**CITY OF SAINT PAUL
HERITAGE PRESERVATION COMMISSION STAFF REPORT**

FILE NAME: 449 Selby Avenue
APPLICANT: John Wiik, Sussel Builders
OWNER: Michael Allen
ARCHITECT: N/A
DATE OF APPLICATION: May 18, 2017
DATE OF PUBLIC HEARING: June 22, 2017
HPC SITE/DISTRICT: Historic Hill Heritage Preservation District
CATEGORY: Demolition and New Construction **WARD:** 1 **DISTRICT COUNCIL:** 8
INVENTORY NUMBER: N/A
CLASSIFICATION: Demo Permit and Building Permit
PERIOD OF SIGNIFICANCE: 1858-1930 **ZONING:** RT2
BUILDING PERMIT #: 17-040370
STAFF INVESTIGATION AND REPORT: Allison Suhan
DATE OF REPORT: June 15, 2017

FLOOR PLAN
SCALE 1/4" = 1'-0"

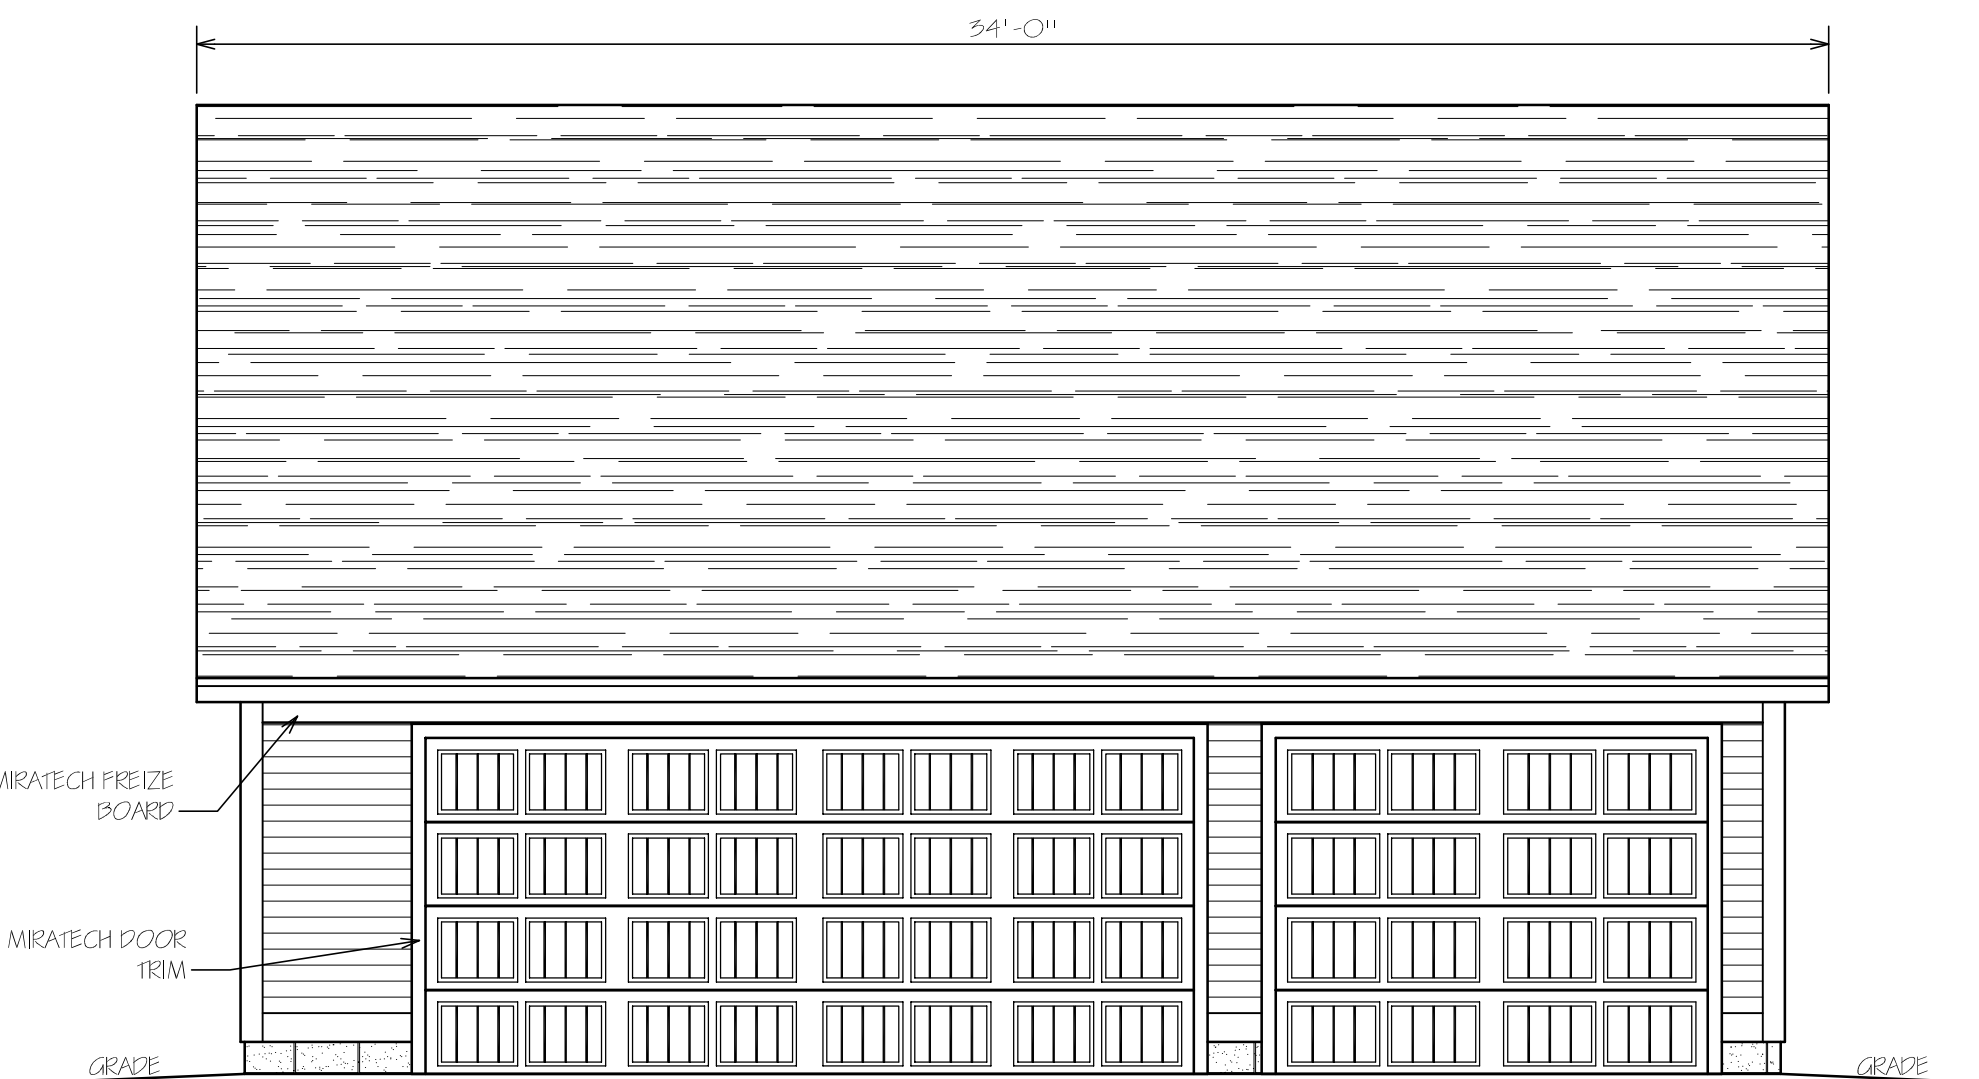
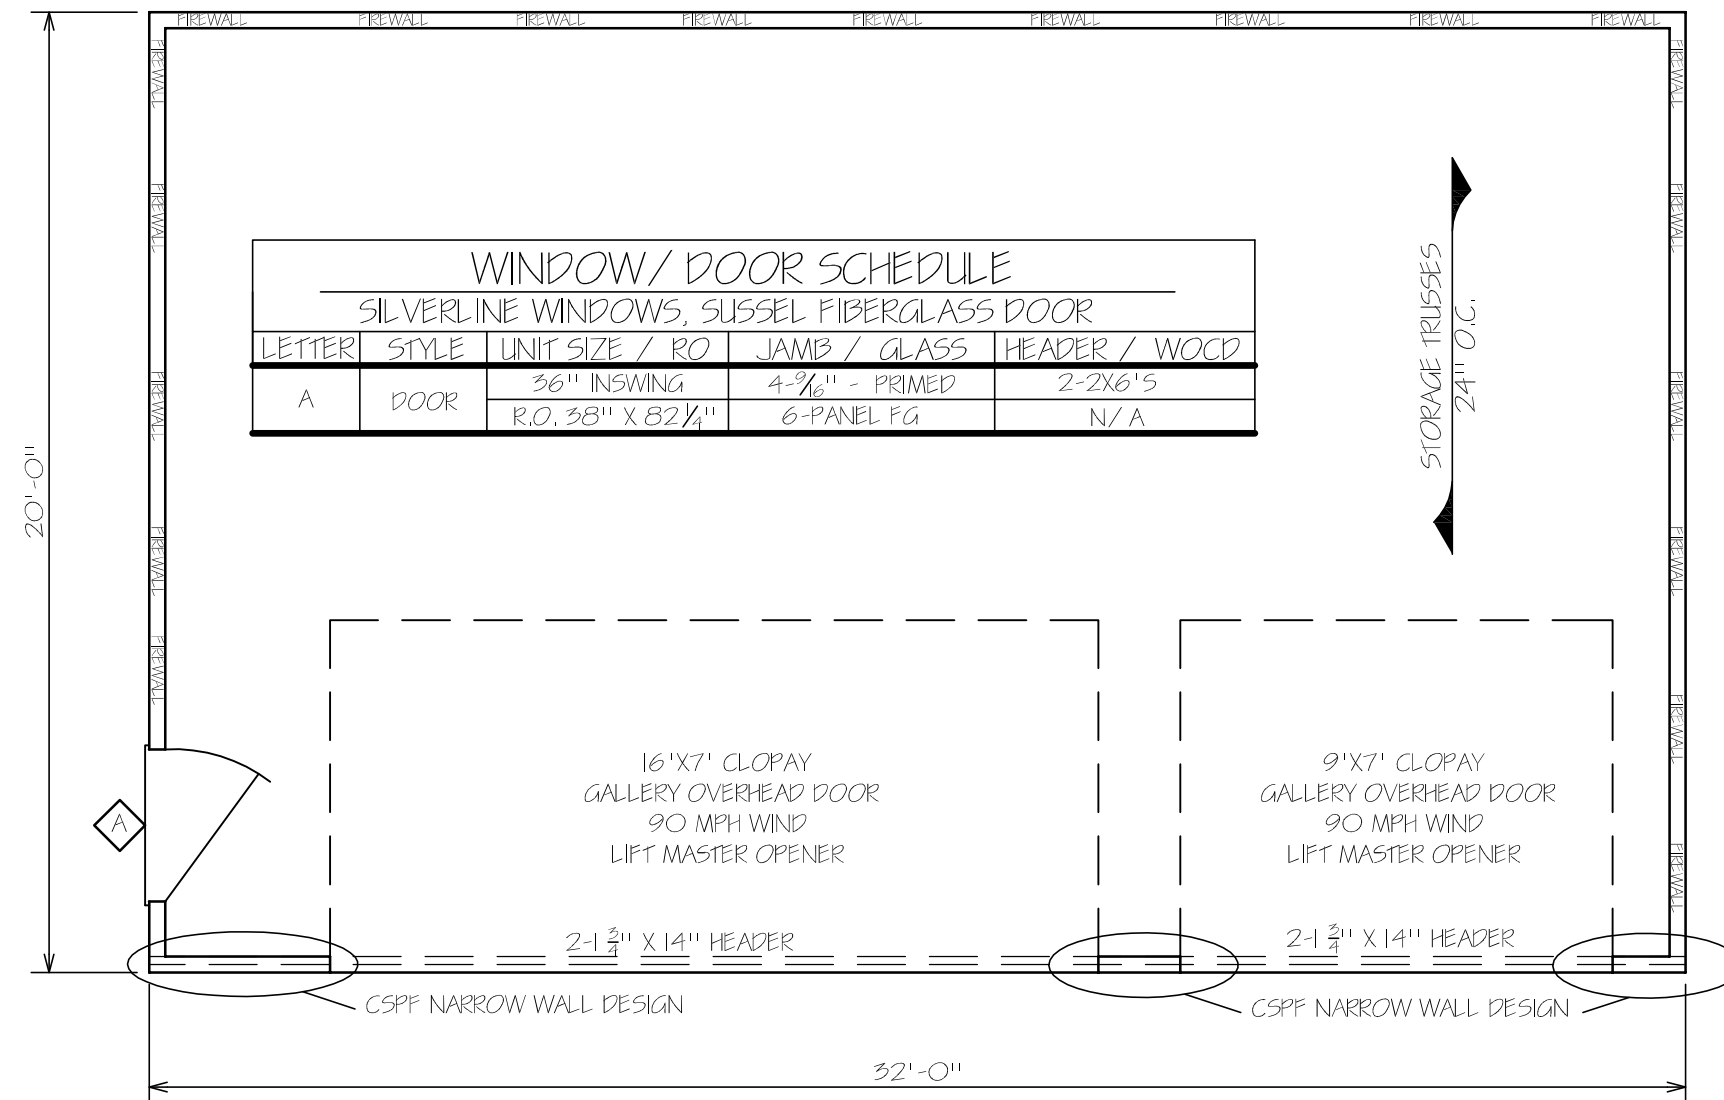
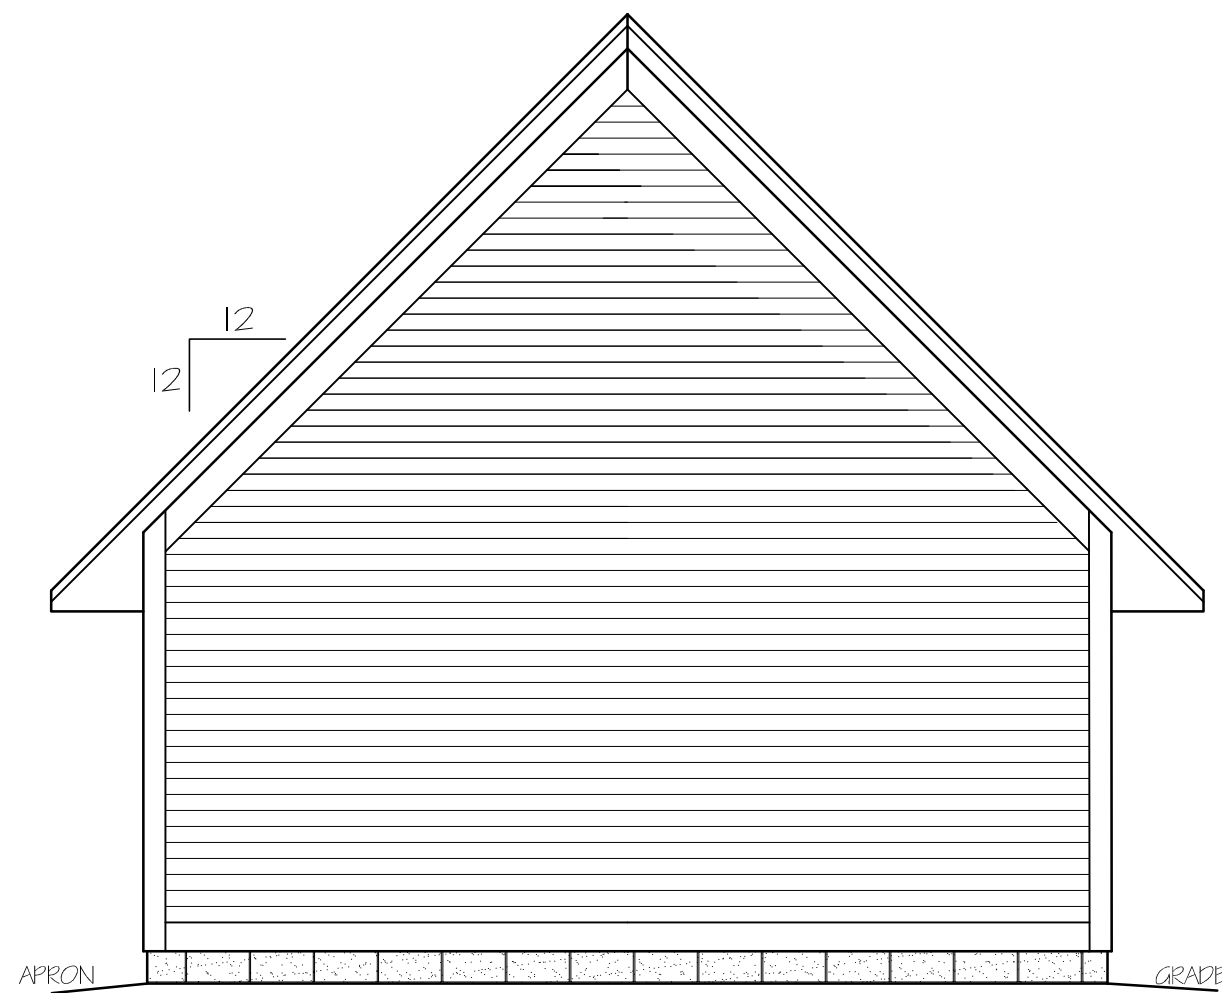
6. Sec. 74.65(e)(1) Roofs. The roof shape and material relates to that of the residence and complies with the guideline so long as it is an architectural shingle in a color that is medium to dark grey or medium to dark brown. A specific shingle was not specified

7. Sec. 74.65(e)(2) Windows and Doors. The service door and garage doors are proposed to be paneled, meeting the guideline. Material was not specified..

1. The asphalt shingle color shall be a medium-to-dark brown or gray – the final color and style shall be submitted to HPC staff for final review and approval.
2. A site plan noting all alterations, materials and dimensions of the driveway shall be submitted to HPC staff for final review and approval.
3. All final materials and details shall be submitted to HPC staff for final review and approval.
4. Any revisions to the approved plans must be reviewed and approved by staff and/or the HPC.
5. The HPC stamped approved construction drawings shall remain on site for the duration of the construction.
